SERVICE BULLETIN Document No. 159-005-01, Rev 0

Model affected: Bell 204B, 205A, 205A-1, 212, 412, 412EP and Garlick UH-1H

Subject: Cargo Hook enhanced safety.

Figure 1 Cargo Hook Assembly

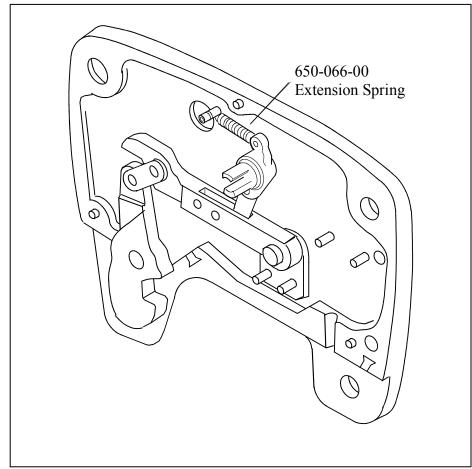
- 4. Remove P/N 650-041-00 Spring, Toggle and replace with P/N 650-066-00 Spring, Toggle.
- 5. Reassemble hook per maintenance manual instructions.
- 6. Perform Acceptance Test Procedure in accordance with Section 8 of manual 120-031-01 or Section 4 of manual 120-044-00, as appropriate.
